re: Response to Engineering Comments
Proposed Residential Development
2710 Draper Avenue - Ottawa

file: PG1630-MEMO.17

Scale:	AS SHOWN	Report No.:	PG1630
Drawn by:	RCG	Drawing No.:	PG1630-4
Checked by:	FA		
Approved by:	FA		
Date:	03/2019	Revision No.:

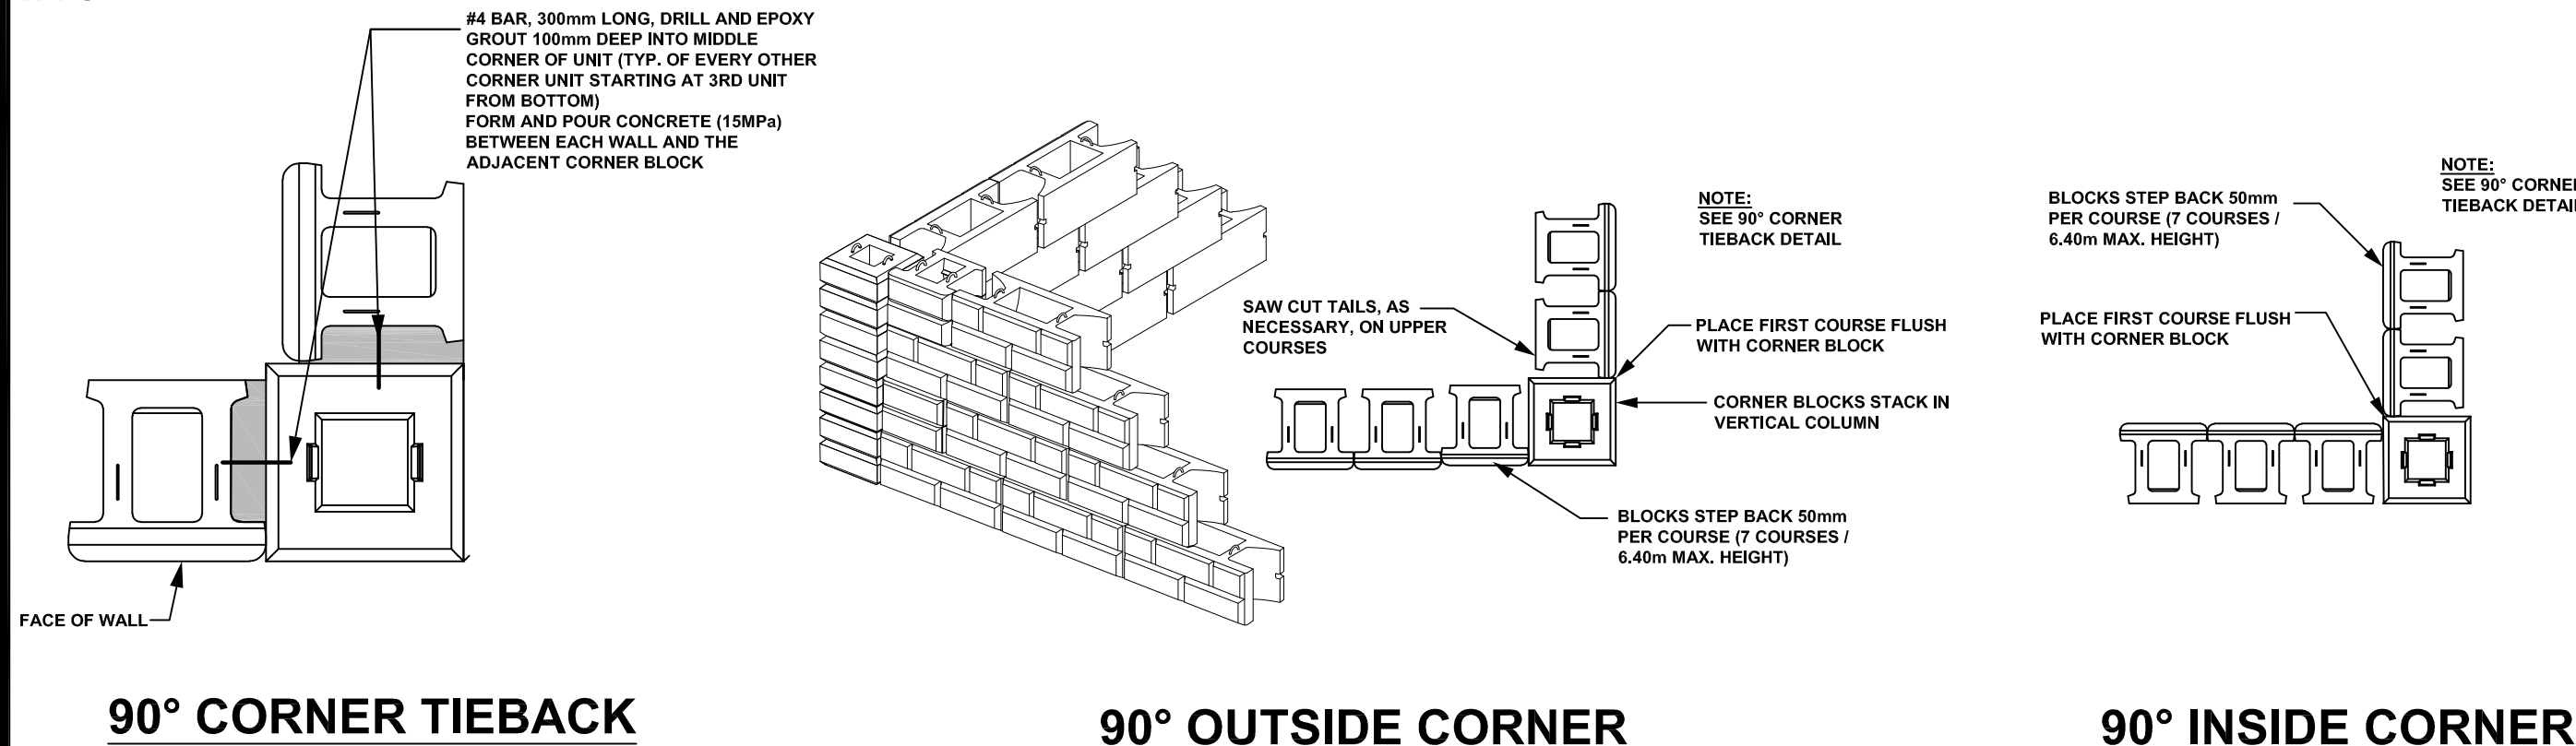
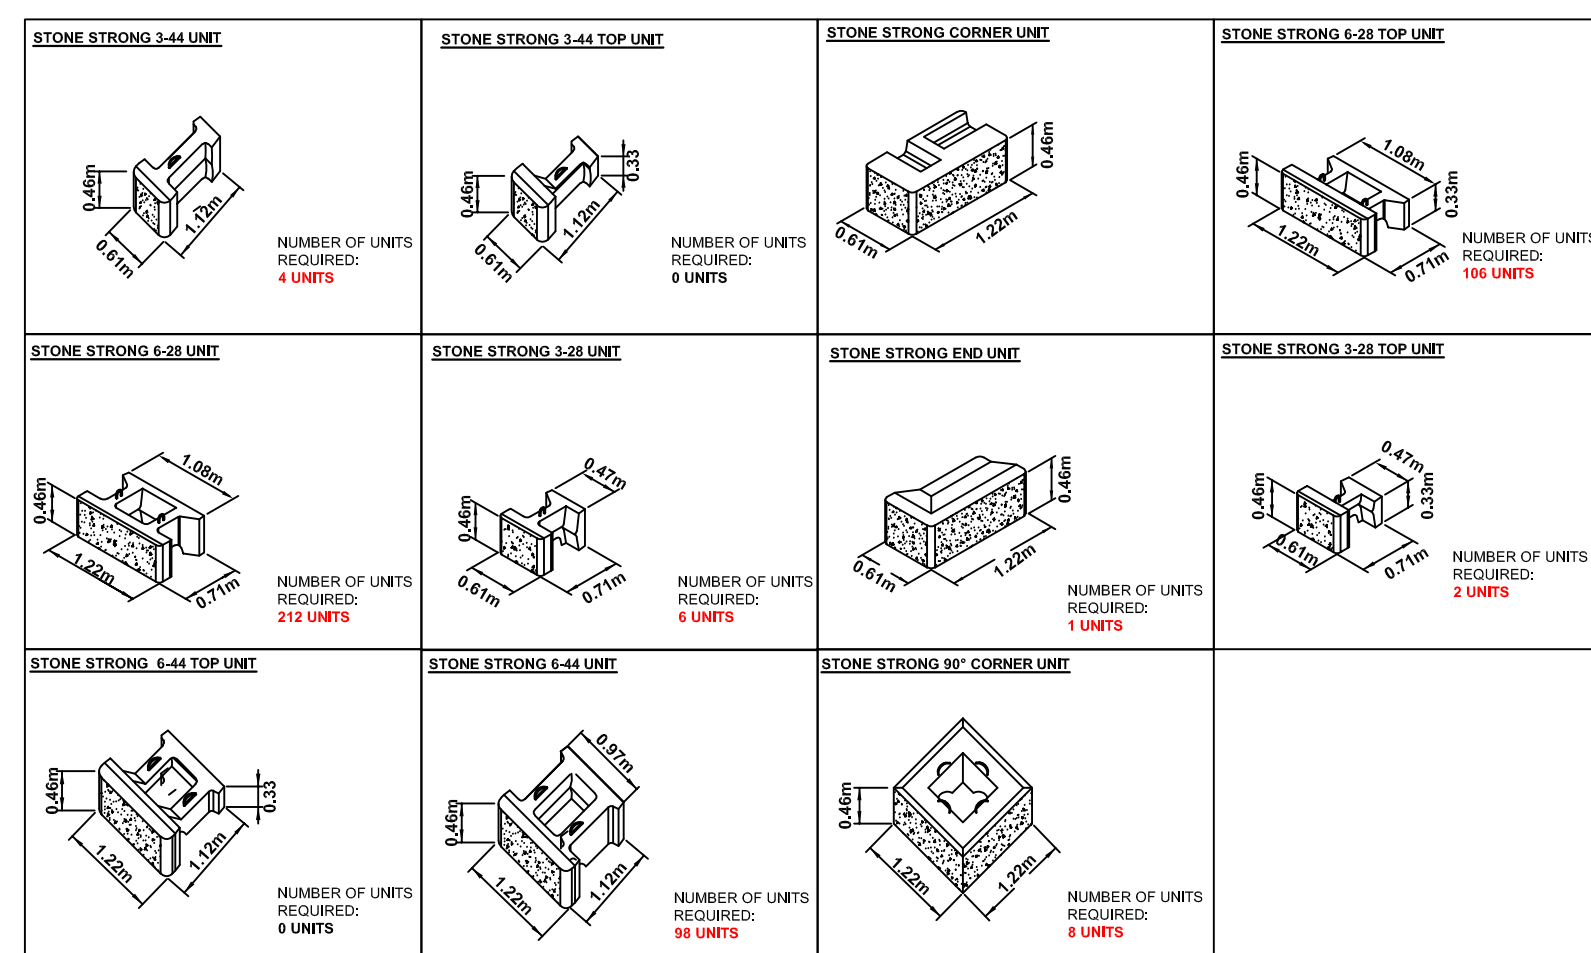
Comment: *A Retaining Wall Stability Analysis Report and Retaining Wall Structural Details are required to be provided that demonstrates that the proposed retaining wall (max height 1.61 m) along the south property line has been assessed for global instability. The cross-sectional structural detail plan to be provided is to be included as part of the civil engineering drawing set as a full size drawing. No retaining wall features shall encroach onto the adjacent lands.*

Comment: *A fence is required along the top of the retaining wall. Proposed fence details shall be shown on the plan to be provided.*

Response: Refer to Drawing PG1630-4 - Stone Strong Retaining Wall Design, attached.

Response: Proposed fence details will be shown on the retaining wall design drawing.
